Job	Truss	Truss Type	Qty	Ply	SMITH DOUGLAS-LANDEN BEH
72516194REP1	A3	Common	5	1	Job Reference (optional)

UFP Mid Atlantic LLC, 5631 S. NC 62, Burlington, NC, JMP

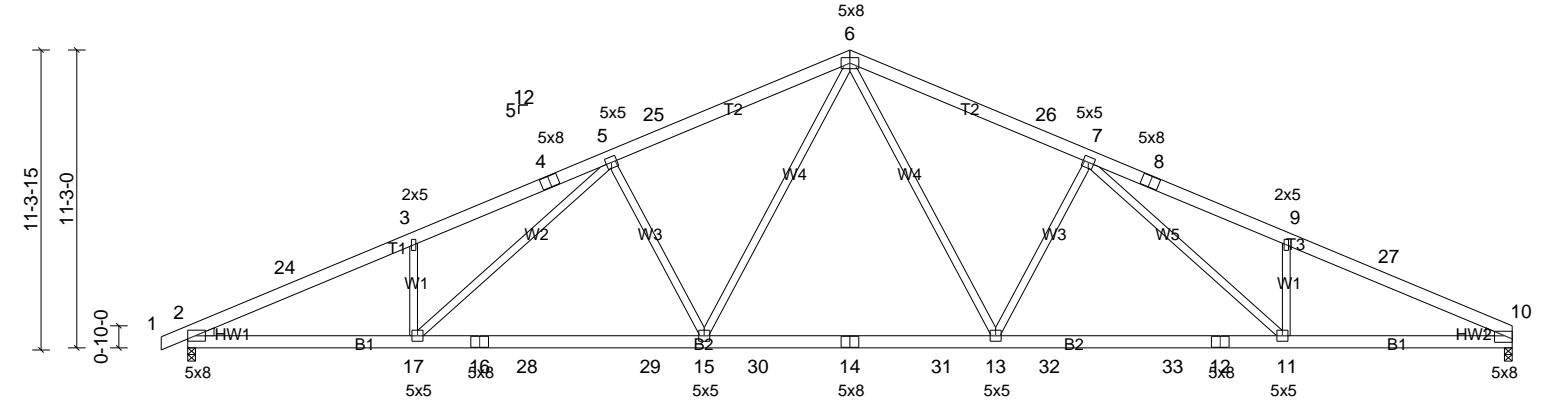
New bearing condition. No truss repair required.

- This repair has been prepared based on information and use conditions supplied by client. Designer has made a good faith effort to outline damage and repair conditions as reported by client. When actual field conditions do not approximate those indicated on this drawing, client shall immediately inform the engineer and refrain from applying the repair.
